CREEKLINE SUBDIVISION, TENTH ADDITION,
RESUBDIVISION OF LOT 1, RESUBDIVISION OF AND
ADDITION TO LOT 8

APPLICATION NUMBER 20 DATE October 3, 2013

REQUEST Subdivision

SITE PLAN

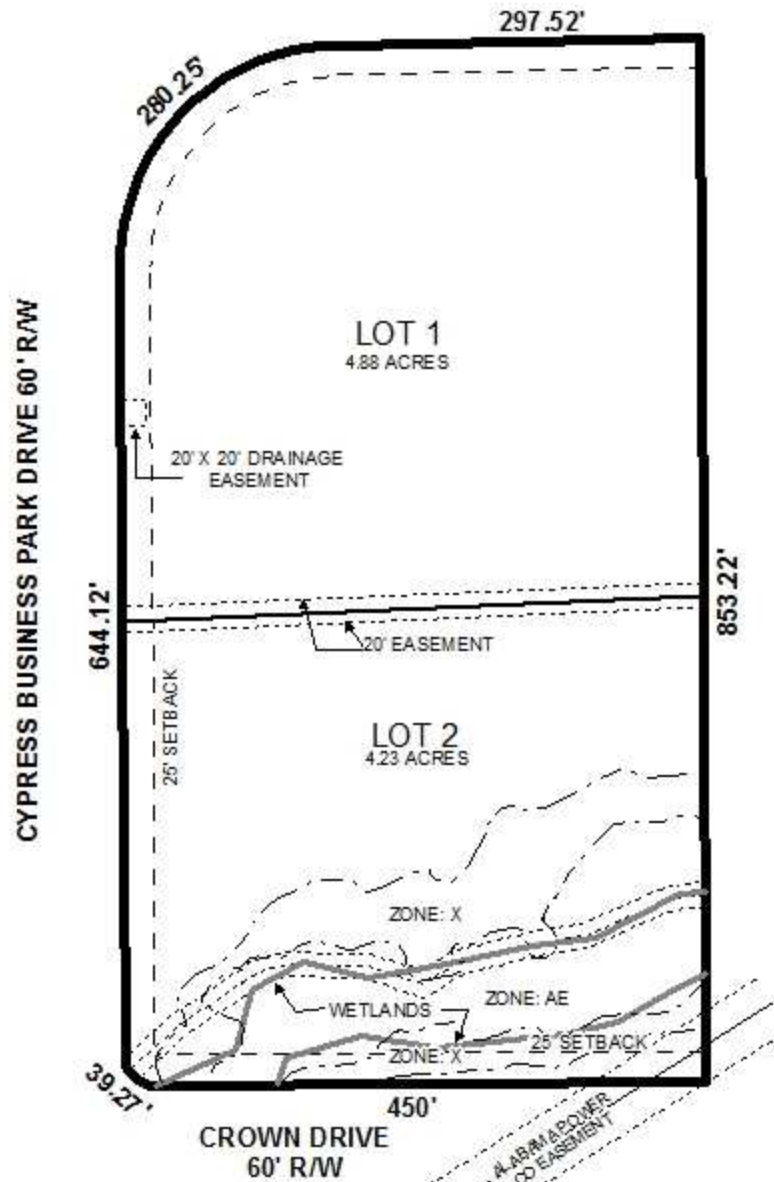
The site fronts Cypress Business Park Drive and Crown Drive which are considered minor streets without curb and gutter, thus requiring a 60' right-of-way as depicted on the plat. As a means of access management, a note should be required on the Final Plat stating that each lot is limited to two curb-cuts with the size, location and design to be approved by Traffic Engineering and conform to AASHTO standards. As on the preliminary plat, the Final Plat should illustrate the 25' minimum building setback line along Cypress Business Park Drive and Crown Drive. Although each lot meets the minimum requirements of the Subdivision Regulations if approved, the plat should be revised to label each lot with its size in both square feet and acres, or a table should be furnished on the Final Plat providing the same information.

Both proposed lots have easements on the property. A note should be placed on the Final Plat stating no structures shall be constructed or placed in any easements.

It should also be noted that a large portion of the proposed Lot 2 is located within the X-shaded and AE flood zones associated with a tributary to Halls Mill Creek. Wetlands associated with the waterway may also occur on a portion of the site. The presence of floodplains would indicate that the area may be environmentally sensitive; therefore, if approved, the approval of all applicable federal, state and local environmental agencies would be required regarding floodplain and wetland issues prior to the issuance of any permits or land disturbance activities.

- 1) labeling of each lot with its size in acres and square feet, or the furnishing of a table on the final plat providing the same information;
- 2) illustration of the 25' minimum building setback line should be retained on Final Plat;
- 3) placement of a note on the final plat stating that approval of all applicable Federal, state and local agencies is required for flood zone and wetland issues prior to the issuance of any permits or land disturbance activities;
- 4) placement of a note on the plat stating that approval of all applicable Federal, state and local agencies is required for endangered, threatened or otherwise protected species, if any, prior to the issuance of any permits or land disturbance activities;
